SUNDRY NOTICES AND REPORTS ON WELLS
Do not use this form for proposals to drill or to re-enter an abandoned well. Use form 3160-3 (APD) for such proposals.

8. Well Name and No.
FLORANCE 86

Proposed P&A Blanco Pictured Cliffs

CONDITIONS OF APPROVAL

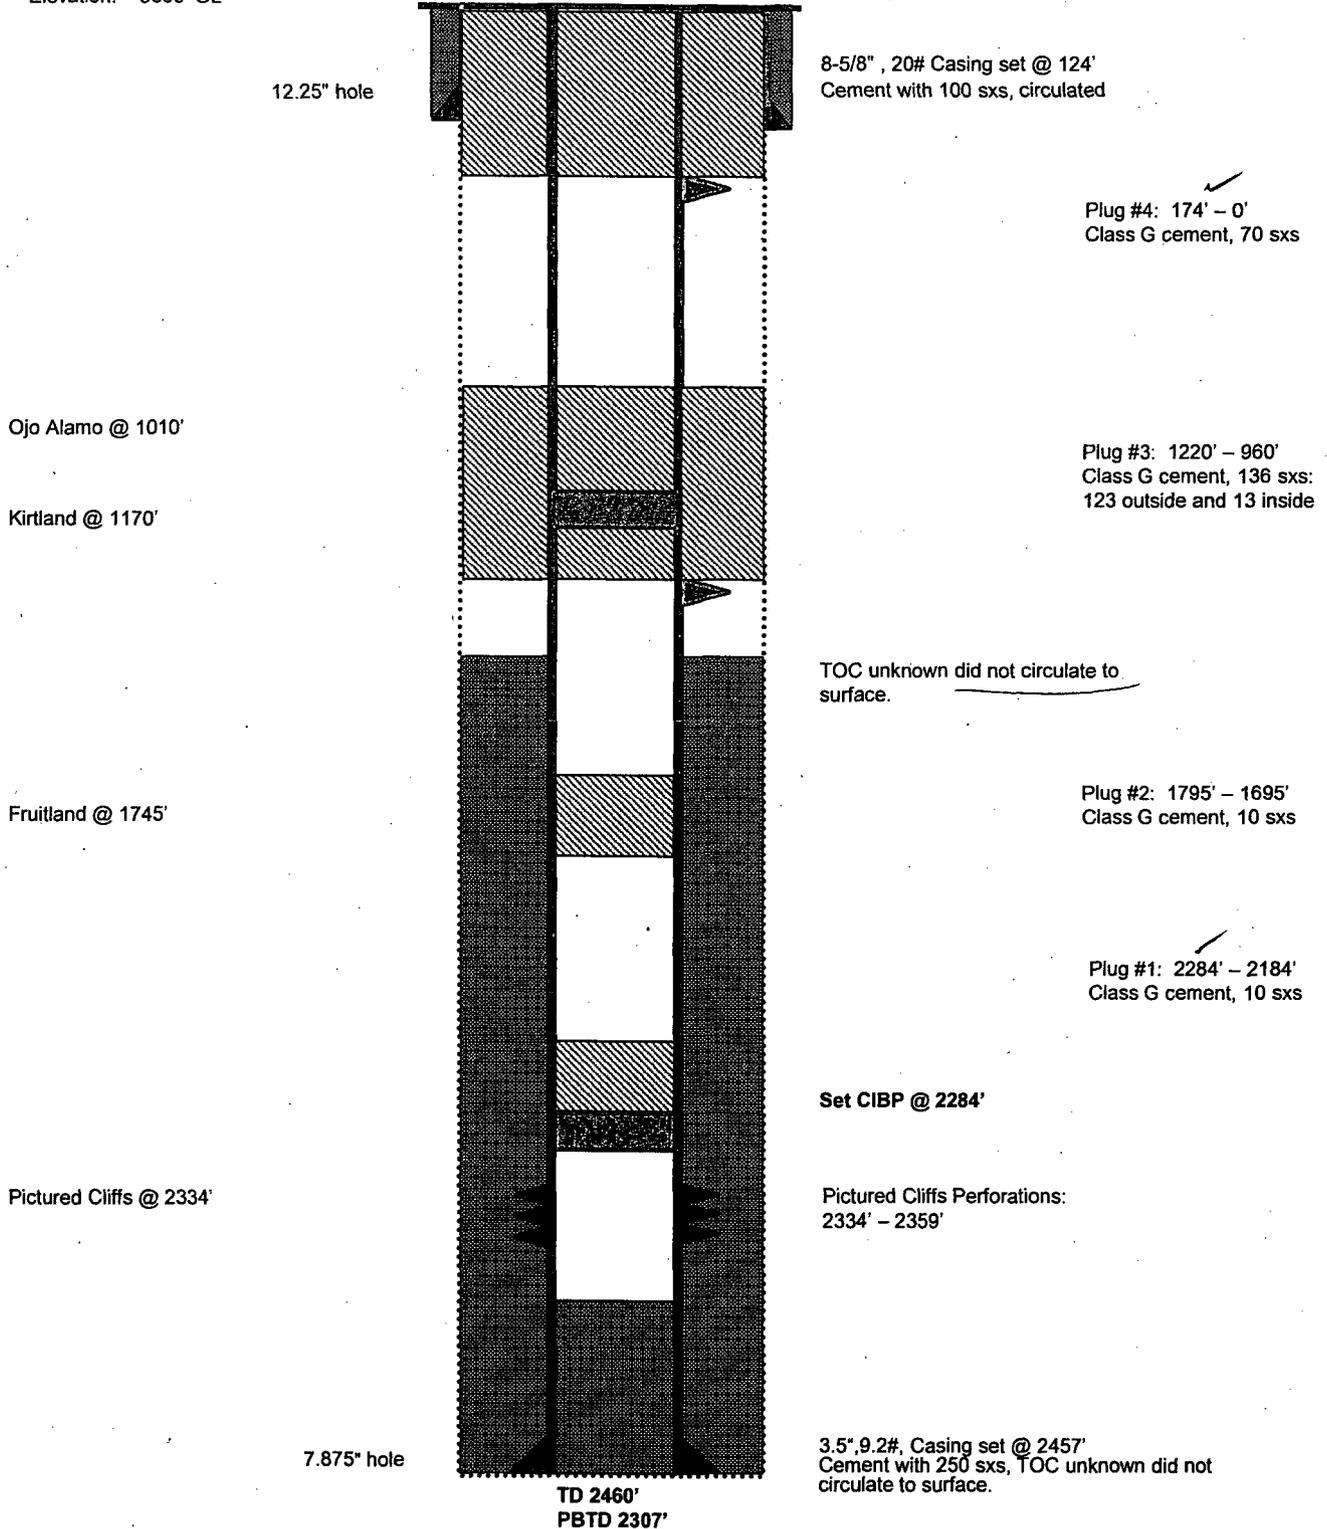
3. The following modifications to your plugging program are to be made:

- a) Set plug #2 (2089 - 1989) ft. to cover the Fruitland top. BLM picks top of Fruitland at 2039 ft.
- b) Set plug #3 (1454 - 1226) ft. inside/outside to cover the Kirtland top and the entire Ojo Alamo interval. BLM picks top of Kirtland at 1404 ft. BLM picks top of Ojo Alamo at 1276 ft.
